**DEPARTMENT OF WATER RESOURCES**

RE: Application for Amendment of Permit for 63-34322

## APPLICATION FOR AMENDMENT OF A PERMIT

5N 1E 33 NESE  
Well

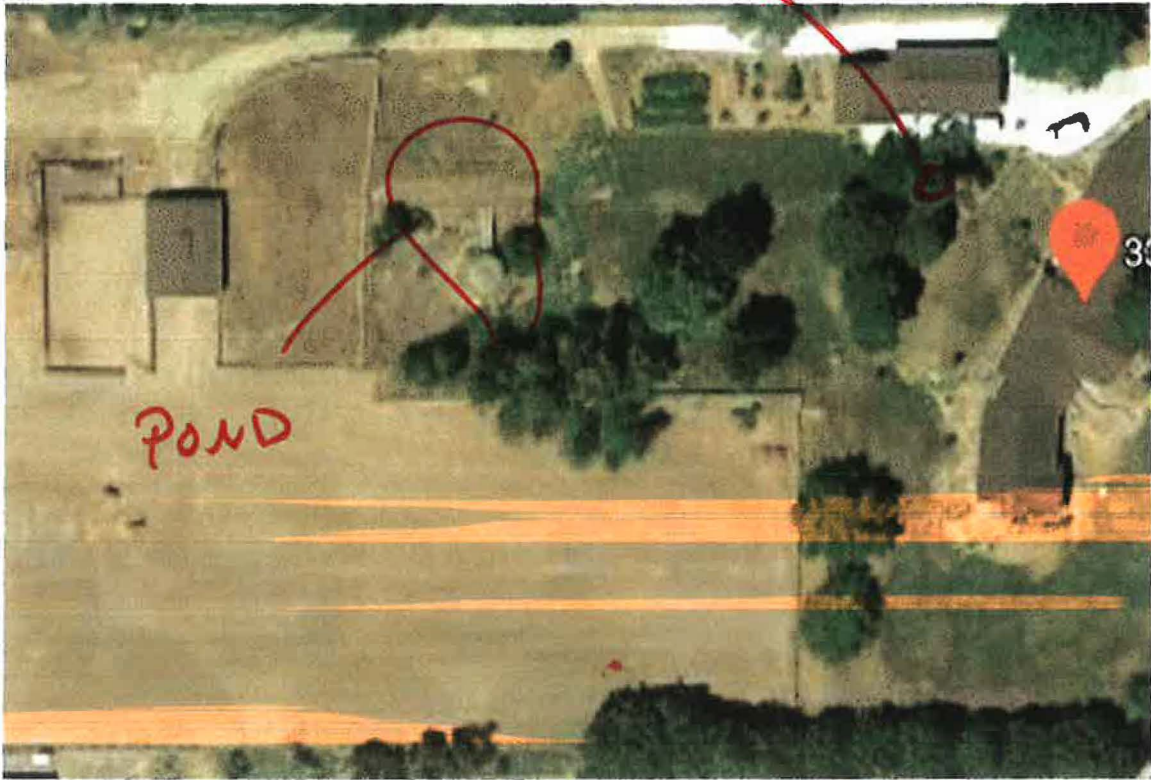
The current point of diversion (POD) for your permit is located in the same legal description as the requested POD change on the application.

As long as your current well meets the criteria for the conditions on this permit, you will not need to drill a new well. Your existing well would need to have a water bearing zone deeper than 200 ft but not deeper than 400 ft. It would also have to be seal and cased to the 200 ft mark. A shallower well is probably tributary to the Boise River. The Department would not approve a shallower well without mitigation and then the application would require the amendment and advertising. If your existing well does not meet these requirements, you will need to drill a new well.

The point of diversion for permit 63-34322 is within the Basin 63 restricted area. Your existing well would need have a water bearing zone deeper than 200 ft but not deeper than 400 ft. A shallower well is probably tributary to the Boise River. The Department would not approve a shallower well without mitigation and then it would require the amendment and advertising. If your existing well isn't deep enough or you do not want to mitigate, you will need to drill a new well.
